ATTACHMENT 1 – Council Submission

SSDA 37 Archer Street, Chatswood

a) Landscape comments

Fig. 2. Extract of Section 02 from Details and Sections (Dwg. No. LA LP 112 / 01) from Appendix F Landscape Plans; RLs indicate a soil depth less than 530mm.

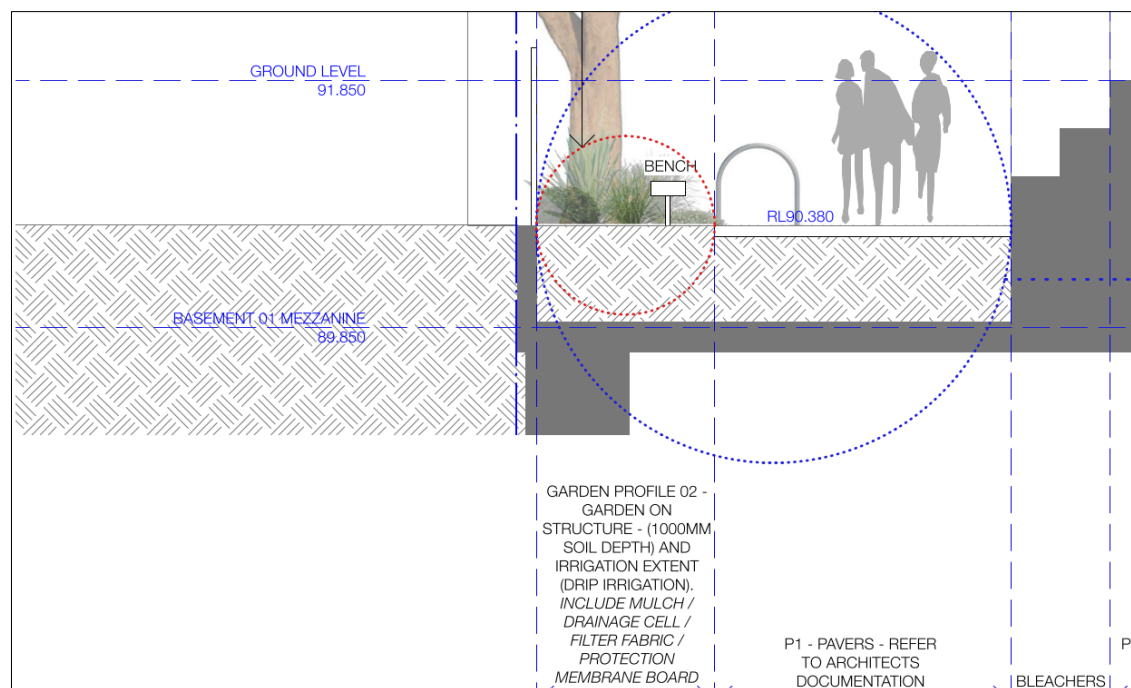
The basement extends to the boundary on the North and South sides. Section 02 on Drawing No. LA LP 112 / 01 within the Landscape Plans (Appendix F) annotate a soil depth of 1000mm to support the landscaping and proposed trees. However, the RLs show a total depth to the basement structure of less than 530mm. Willoughby DCP requires a minimum of 600mm soil depth to be included in landscape area calculations, this area

should also be for planting of trees shrubs and grasses and should be not include areas of paving.

For planting of large canopy trees (13-18m high with 16m spread) on structures the Apartment Design Guide (ADG) requires a minimum depth of 1200mm, with an area of 10m x 10m or equivalent with a soil volume of 150m³ per tree; the landscape plans show 5 trees which exceed 18m in height to be planted on structure. These figures from the ADG also assume fortnightly irrigation.

A **minimum** soil depth of 1200mm could be capable of supporting the proposed canopy tree species. The required soil depth must exclude any subsurface drainage provisions and surface mulch, therefore, a depth greater than 1200mm must be provided to the top of the basement structure.

Fig. 3. Extract from Landscape Plan – Soil Volume (Dwg. No. LA LP 109 / 02) overlaid on Landscape Plan – Level 01 (Dwg. No. LA LP 101 / 02) from Appendix F Landscape Plans; Soil volume of through site link.

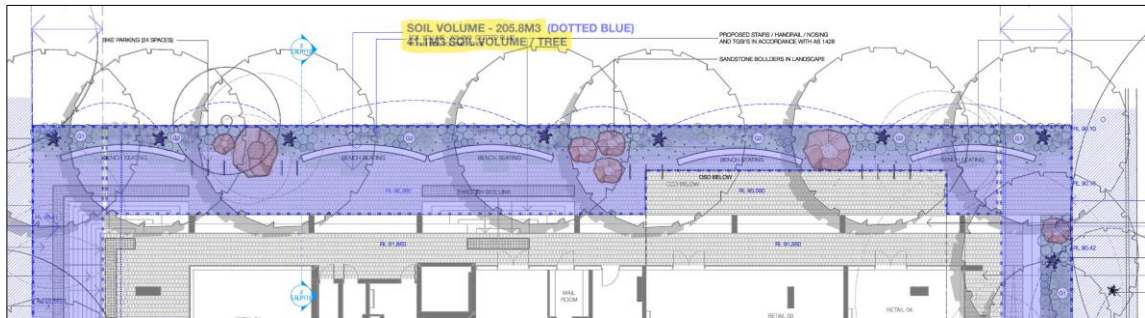
In addition to the minimum soil depth requirements, sufficient soil volume must also be provided to support the trees. The landscape plans show a total soil volume for the area over structure being 205.83m³ equating to 41.1m³ per tree, which is insufficient to support large canopy trees. Noting also that majority of this soil area is covered by paving, which limits gaseous exchange for feeder roots.

Fig. 4 Extract from Section A (SSDA 205) from Appendix D Architectural Plans; shallow soil area and isolated from opportunity to connect with landscape area on neighbouring site.

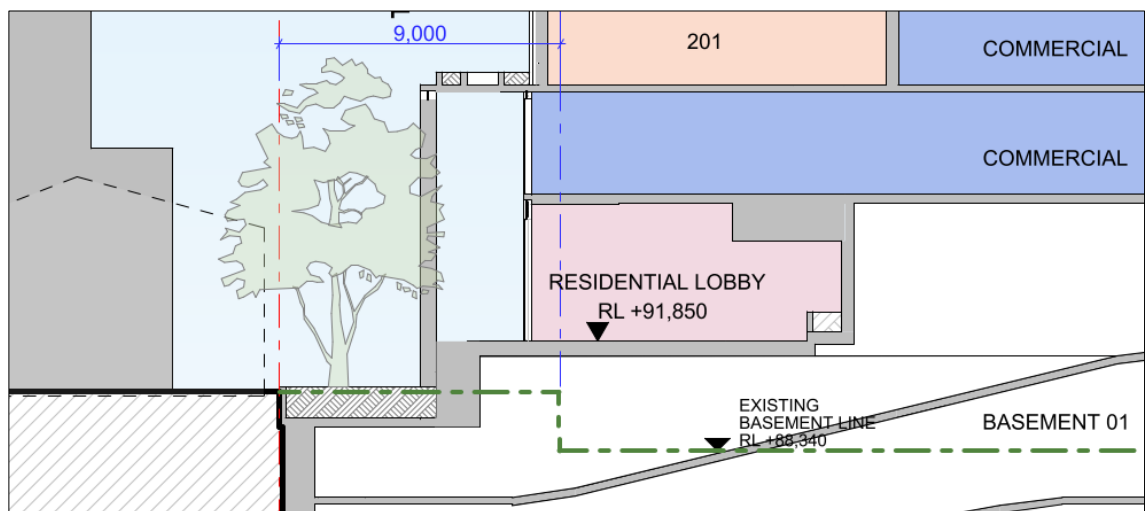
The Section 02 also shows a wall along the boundary which removes any opportunity for the site to the north to provide contiguous soil areas that can benefit the landscaping of both sites.

Fig. 5. Landscaping within the northern side setback.

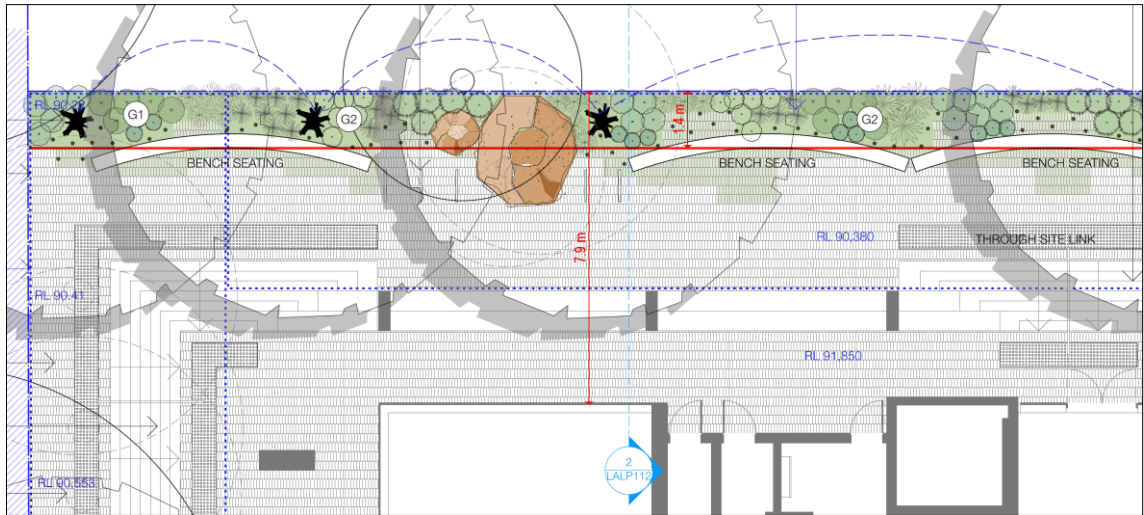
The landscape area provided in the through site link is less than 18% of the setback to the building. The average width of landscaping is approximately 1.4m from the 7.9m setback to the building line (As measured from the landscape plans).

A greater area of soft / green landscaping should be provided within the northern side setback.

Fig. 6. 3D rendering with planters integrated to the bleaches highlighted with yellow circles.

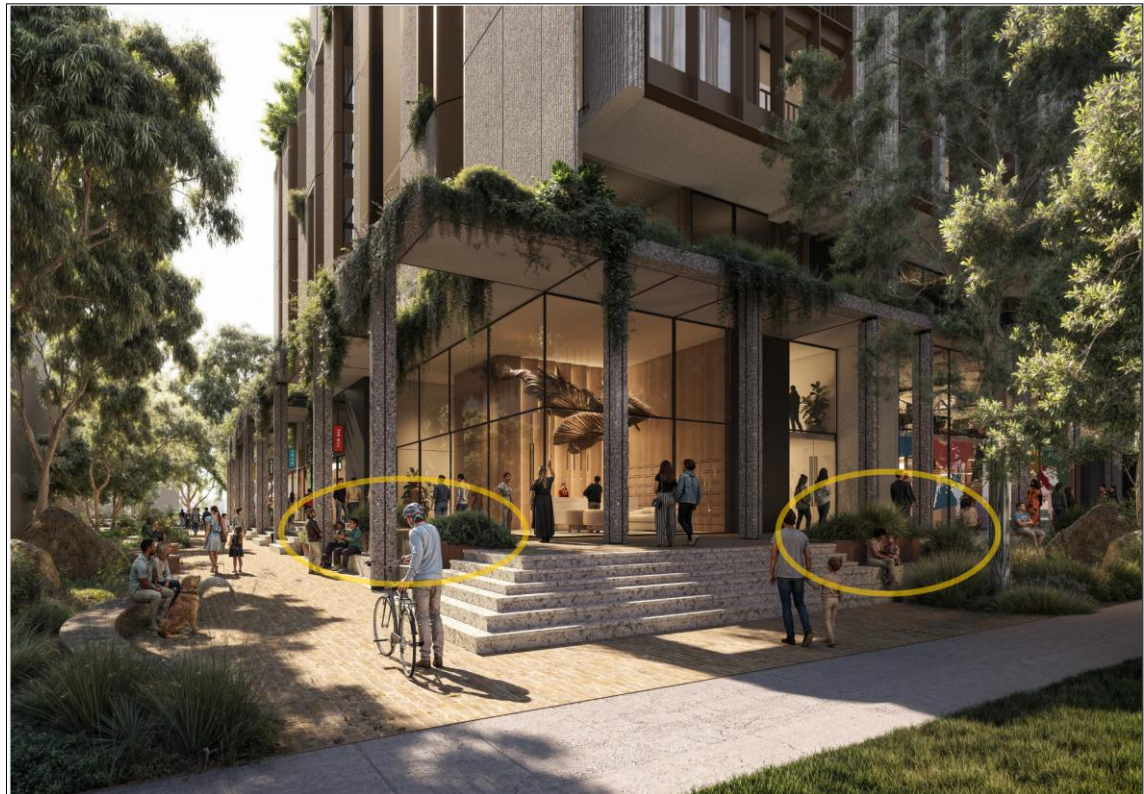
The 3D rendering show planting areas mixed in with the bleaches along the through site link and along Archer Street, which is not shown on the landscape plans. Integration of planting with the bleaches, perhaps in a staggered or alternating arrangement, should be considered in providing more planted landscape area within the northern side setback.

Fig. 7. Narrow points of through site link pathway should be considered to prevent choke points.

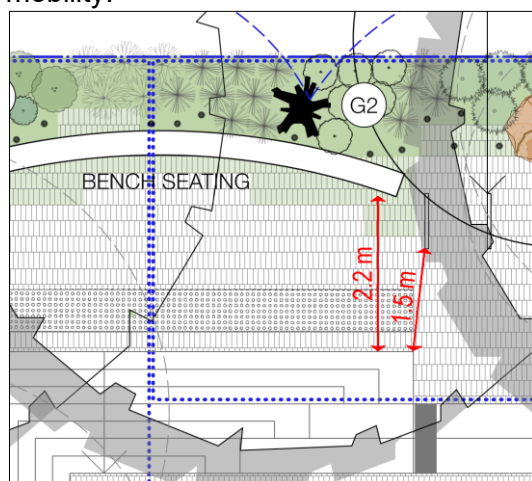
While increasing the planting areas, positioning of structures such as bike paths and benches restricting pathway width should be considered to avoid creating narrowing choke points. Minimum clearances must comply with AS 1428.1:2021 Design for access and mobility.
